194-198 HIGH STREET

SUBJECT: In reference to the buildings at 194-198 High Street

Re: 194-196-198 High Street

194-198 High Street

2nd floor Plan Scale 1/4" = 1'

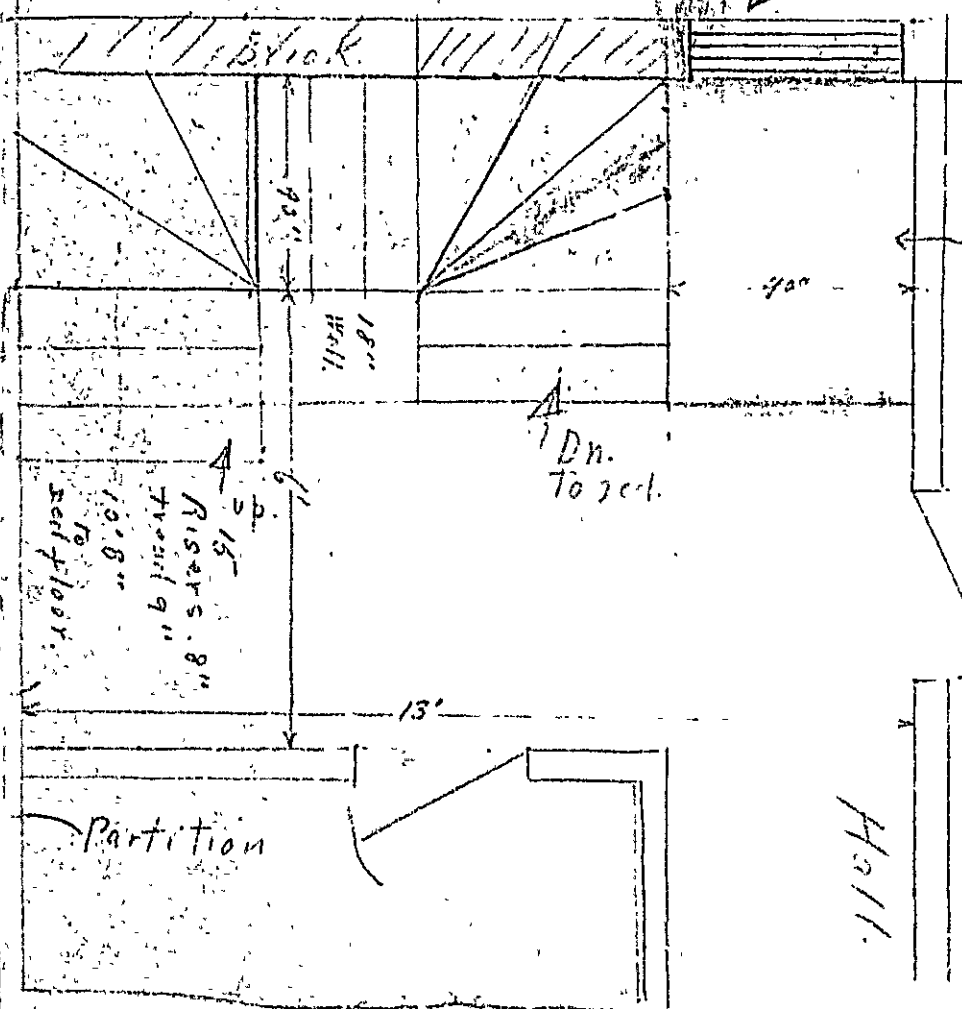
3' Door opening  
fire door  
Details  
Class C fire door  
2 hrs fire resistance  
casings METAL clad.  
↳ Irons 3"x3"x1/6"  
for Headers
